COUNTY DEPARTMENT AGENDA REQUEST

Consideration of Petition No. RP-048-10, SELAF Haddonstone Holding Company, LLC, Owner, and Jason Wingfield, Agent, request a revision to a Recorded Final Subdivision Plat for Haddonstone Subdivision to subdivide the Amenity Area into two (2) single-family dwelling lots. This property is located in Land Lot 35 of the 5th District, fronts on Loggia Point, and is zoned R-50.

PLANNING COMMISSION REZONING REPORT

PETITION NO.: RP-048-10

PROPOSED LOTS 54 AND 55 HADDONSTONE SUBDIVISION THE AMENITY AREA WILL BE RELOCATED TO LOT 33 LOCATED ON BERGEN DRIVE

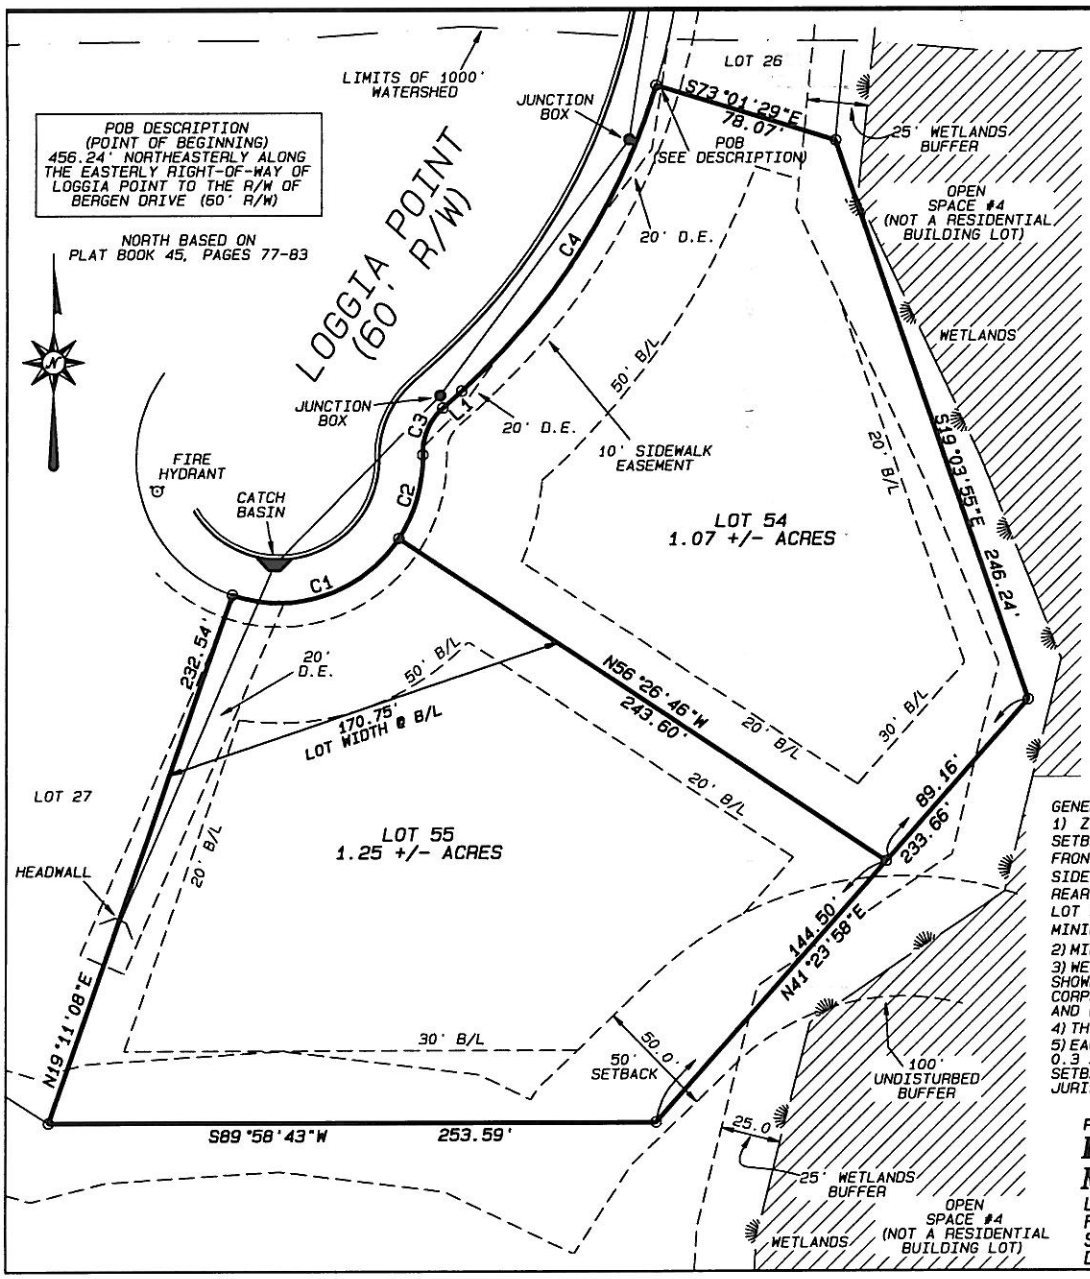
Should this request be approved, a Revised Final Plat of Haddonstone Subdivision must be submitted, approved, and recorded prior to the issuance of any building permits for said lots. The Revised Final Plat shall also include Lot 33 which shall be labeled: "Amenity Area – Not A Residential Building Lot – For Recreational Purposes Only (formerly Lot 33)."

Water: The developer is responsible for installation of service taps. (Tony Parrott)

Environmental Health Dept.: The department has been in communication with Jason Wingfield regarding this matter. The department has performed lot evaluations, evaluated Level 4 Soil Surveys and reviewed individual sewage disposal system designs for both proposed lots. The property boundary lines on the system designs appear to mirror lot boundaries in the transmittal. The department is positioned to approve the revision for plat recording purposes only. (Jeff Kilgore)

Stormwater Management: The property does not contain floodplain per FEMA FIRM panel 13113C00111E; however, the applicant shall delineate future floodplain conditions. The property **does not** contain wetlands per the U.S. Department of the Interior, Fish and Wildlife Service 2008 National Wetland Inventory Map or per the recorded Final Plat. Watershed applies to the property and buffers on the original Final Plat and will stay the same. The property is not within a groundwater recharge area. (Bryan Keller)

Based on review by staff, this request complies with all technical requirements of a Revised Final Plat.
